# CONSTRUCTION PLANS FOR THE RIDGE AT LORSON RANCH FILING NO. 3

## STREET & STORM SEWER CONSTRUCTION PLANS

**AS-BUILT**  
STREET-STM  
FEB 9, 2024

SHEET NUMBER C1.1

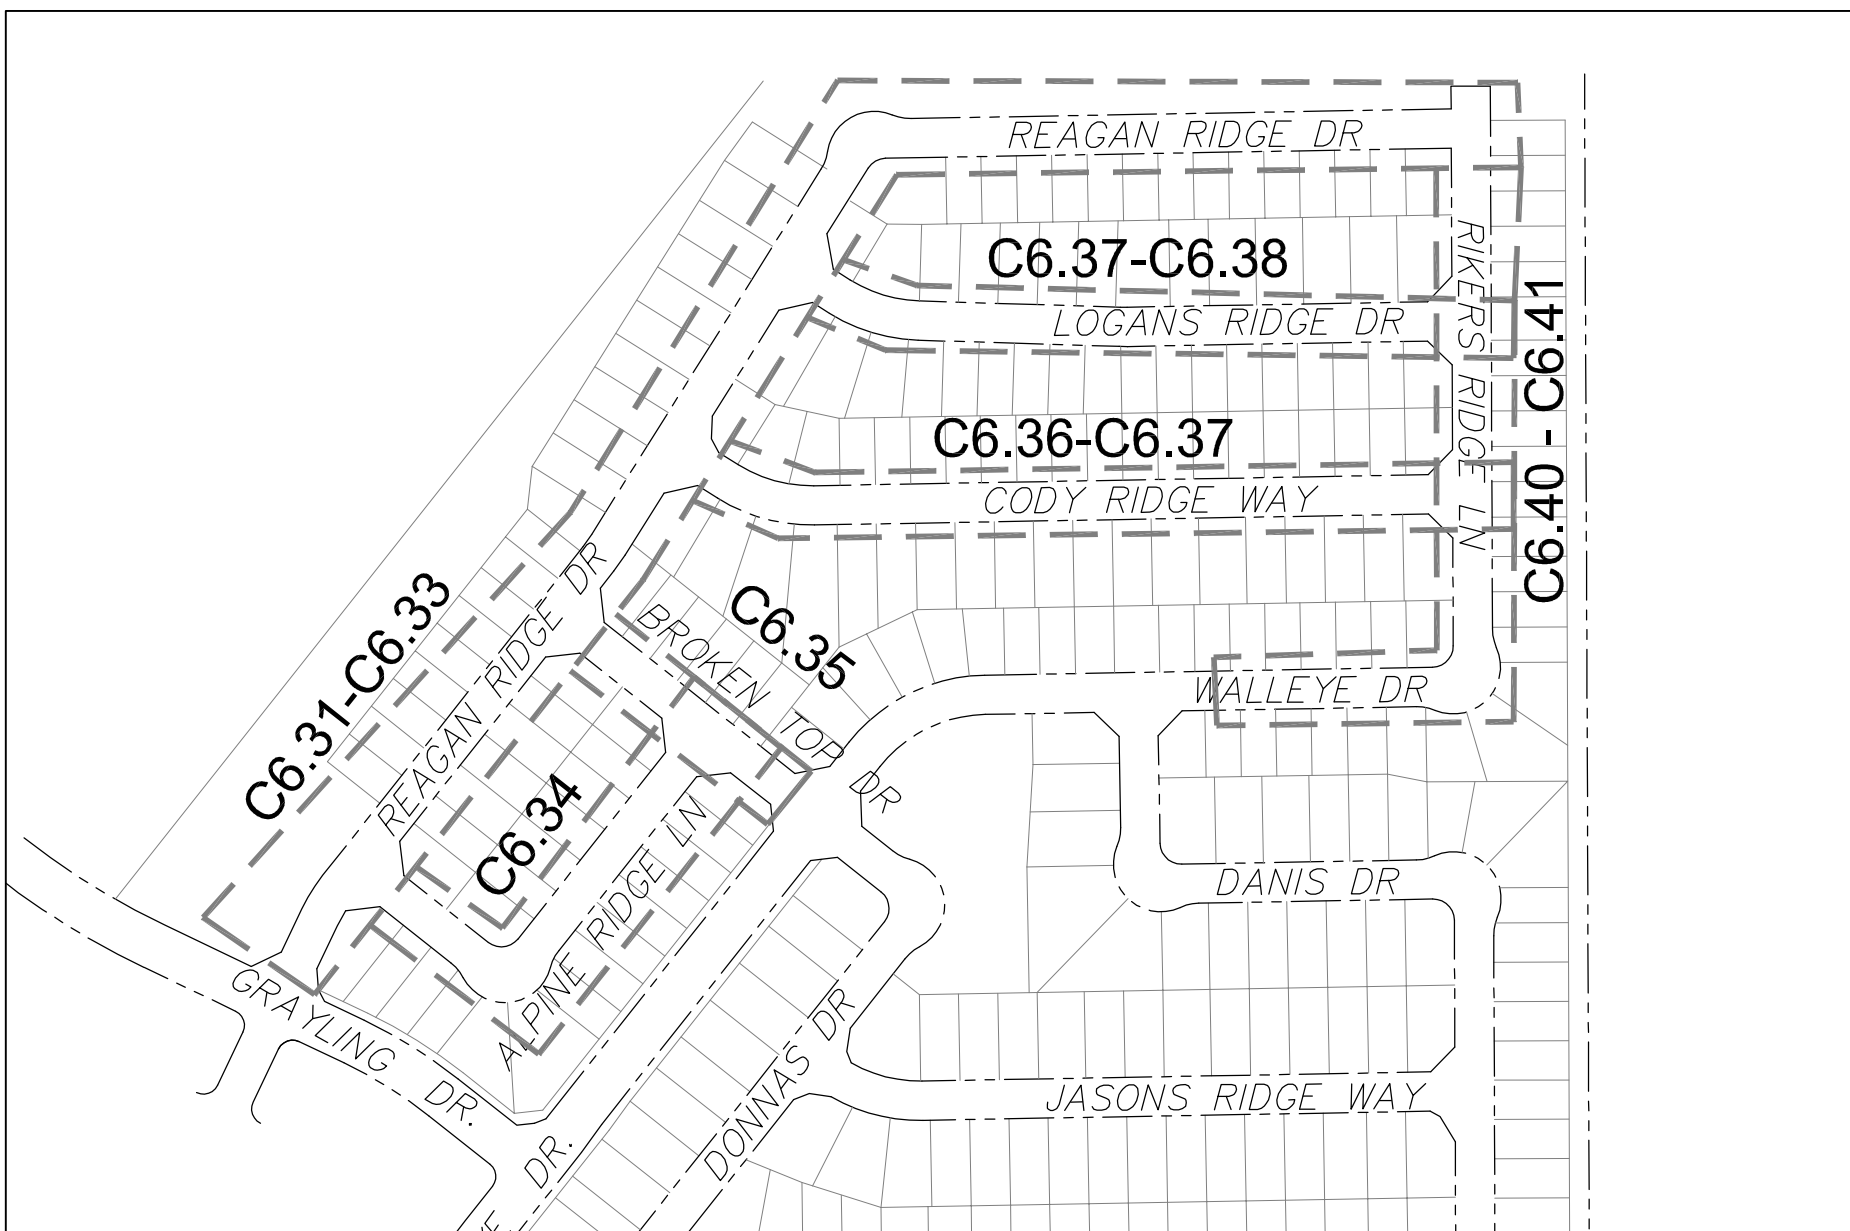
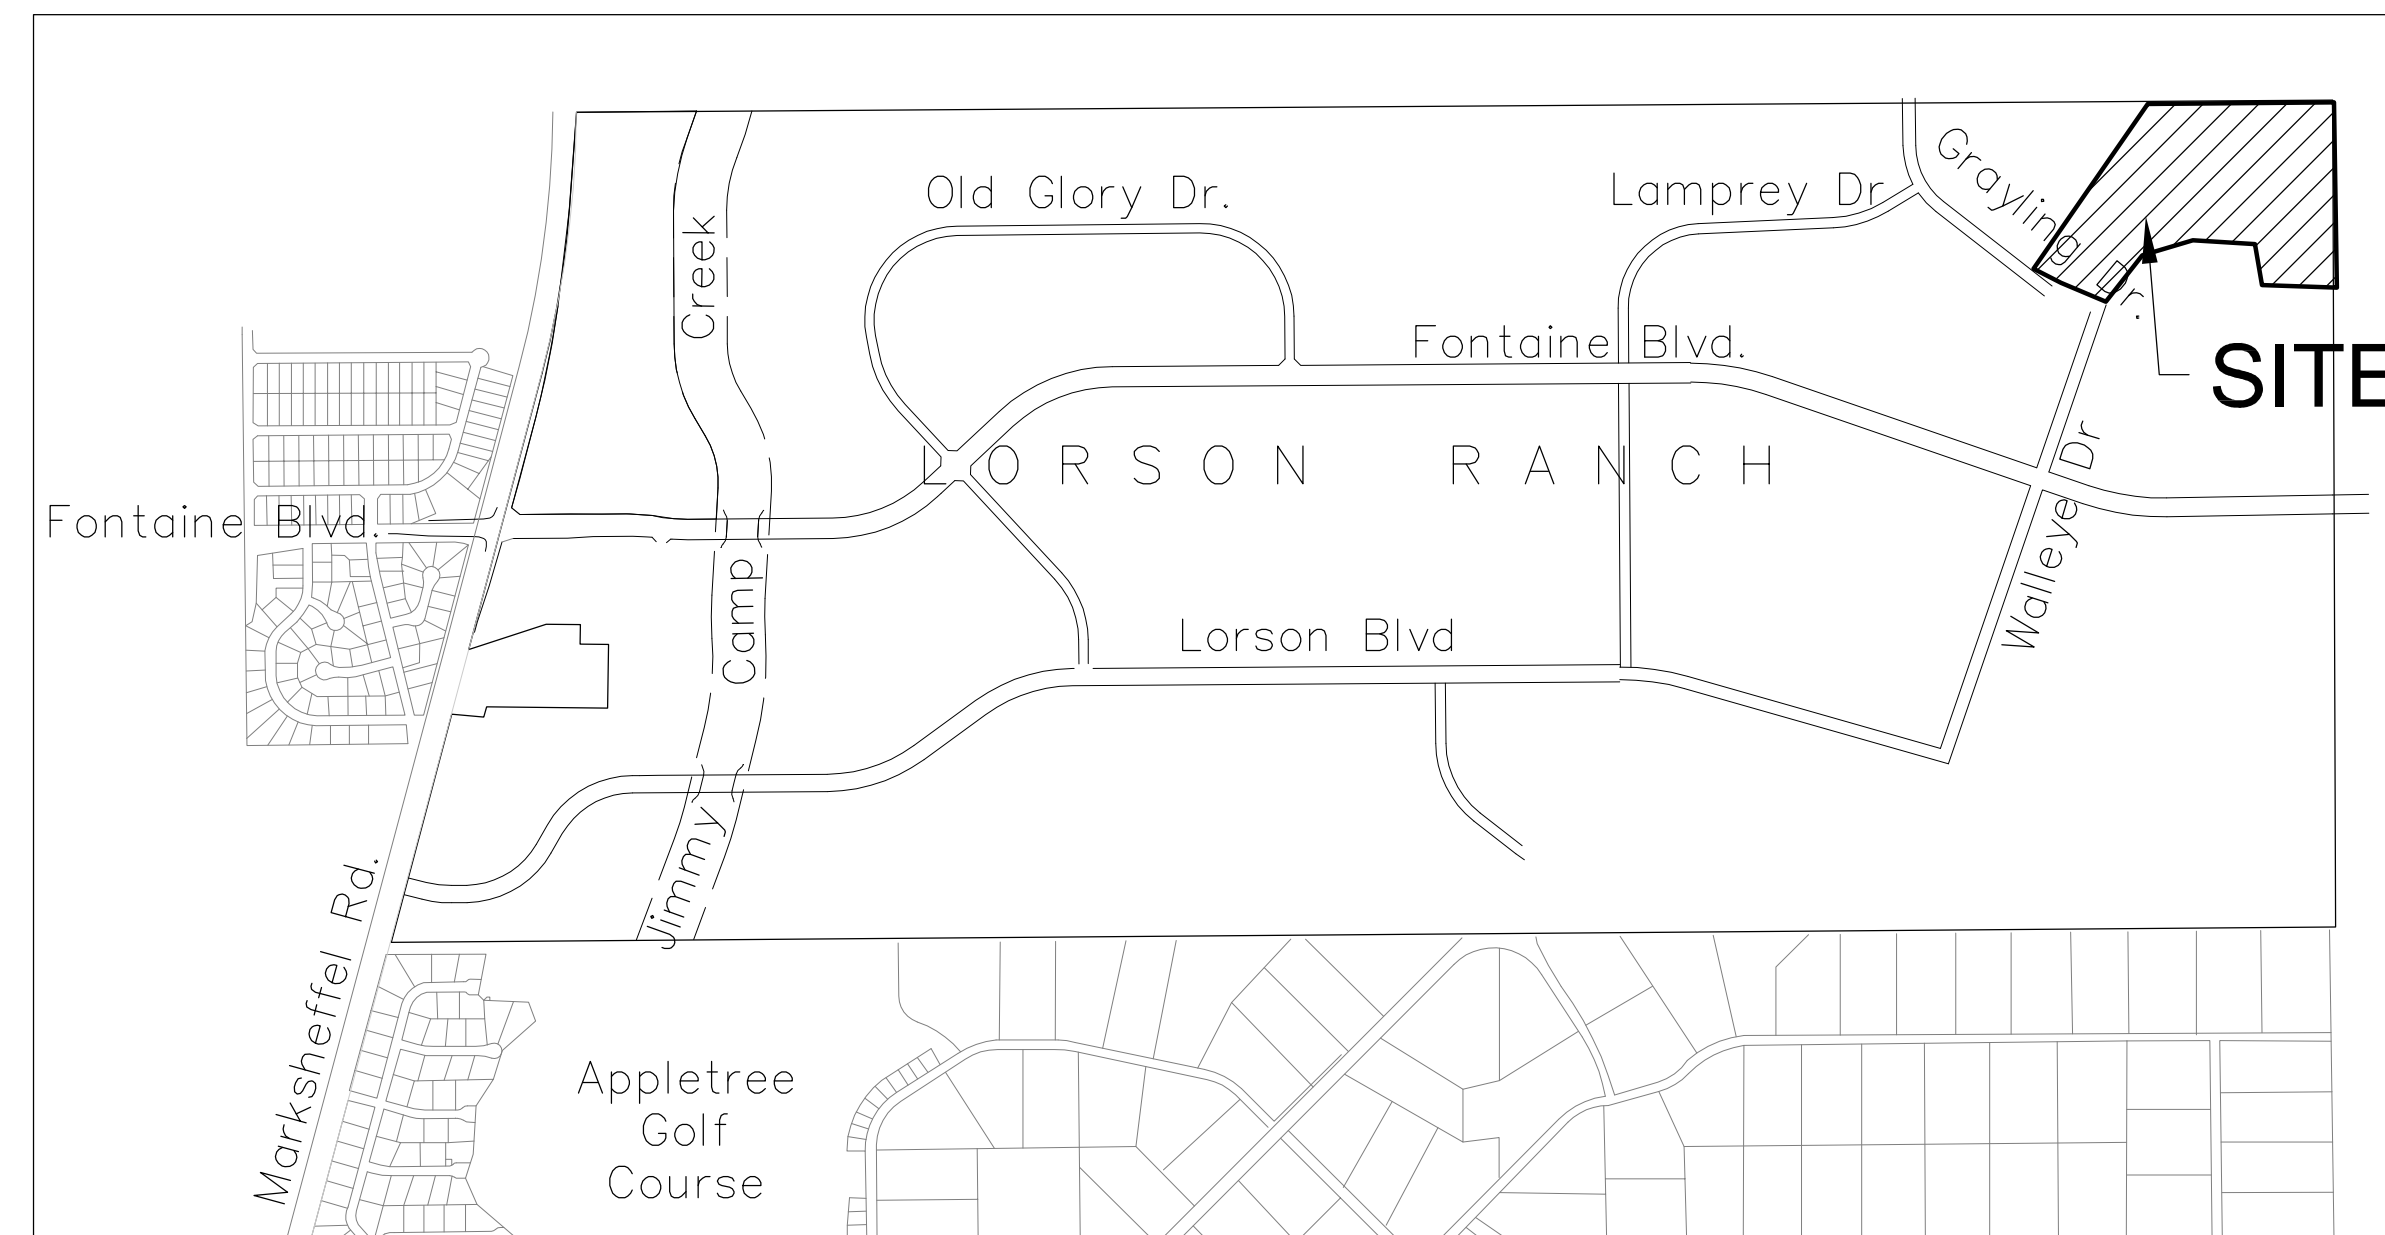
Rich, see my comment at the top of the Pond Cert Letter for ASB245 - The Ridge at Lorson Ranch F1 and update Filing 3 docs accordingly.
